Peach Bottom Atomic Power Station, Units 2 and 3
Facility Operating License Nos. DPR-44 and DPR-56
NRC Docket Nos. 50-277 and 50-278

Subject: Response to Request for Additional Information Related to Time-Limited Aging Analyses

**Exelon Generation Company, LLC (Exelon)
License Renewal Application (LRA)
Peach Bottom Atomic Power Station (PBAPS), Units 2 and 3**

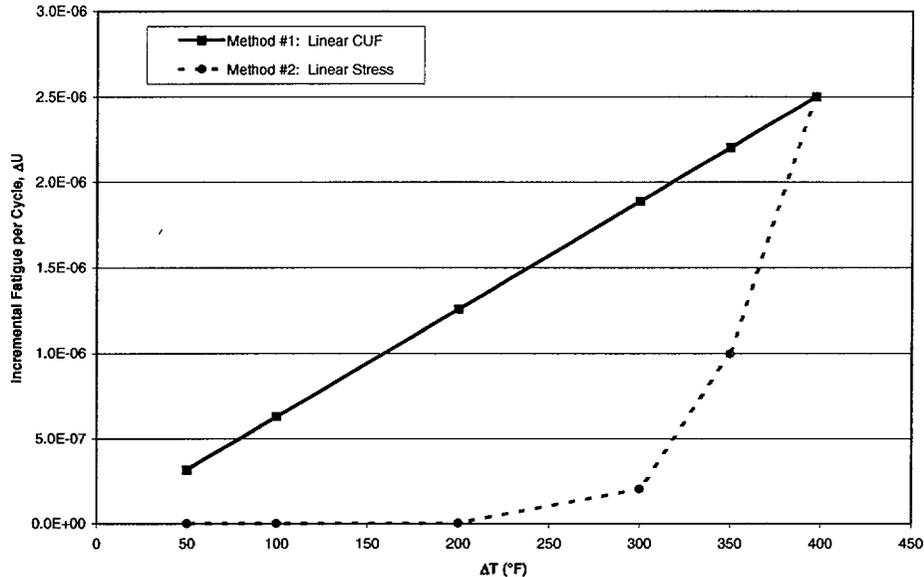
Section 4.3.2.1 of the LRA indicates that fatigue analyses of the core shroud supports were reevaluated for effects of increased recirculation pump starts with the loop outside thermal limits. Describe the reevaluations that were performed considering an increase in recirculation pump starts. Indicate the reason that the reevaluations were necessary.

At issue are thermal events associated with the PBAPS Technical Specification requirement that limits the temperature difference (ΔT) between an idle recirculation loop and the vessel coolant to be within 50°F of each other prior to pump start. Specifically of concern is the ΔT following initiation of the first of two idle recirculation pumps. Since PBAPS has experienced events of this type in the past, the plant Technical Specifications requirements triggered the evaluations in question.

The design basis Sudden Start event provides conservative and convenient criteria for accounting for the actual events experienced at the PBAPS units. This design basis event is much more severe than the events actually experienced at PBAPS, as the actual ΔT s were significantly lower than the ΔT evaluated for the design event. Since the design basis event consists of a very conservative step change in temperature, the fatigue contribution for this event is driven almost exclusively by the ΔT during the event. Therefore, the ΔT of the actual events were compared to the ΔT of the design basis events to establish partial cycle counts for these events. This method leads to revised CUF estimates that are linear with respect to ΔT , which is conservative compared to more traditional CUF estimates where stress is linearly related to ΔT . The conservatism of this method is demonstrated in Figure 1. Since the Sudden Start event is a primary contributor to the shroud support CUF value, this component was selected for evaluation of these events. Other affected RPV and piping locations were also evaluated, but were less limiting than the shroud support from a CUF perspective. Note that although the shroud support is not an ASME Code pressure boundary component, it was considered in this evaluation since it was included as a part of the original ASME Code, Section III design basis evaluation for the reactor pressure vessel.
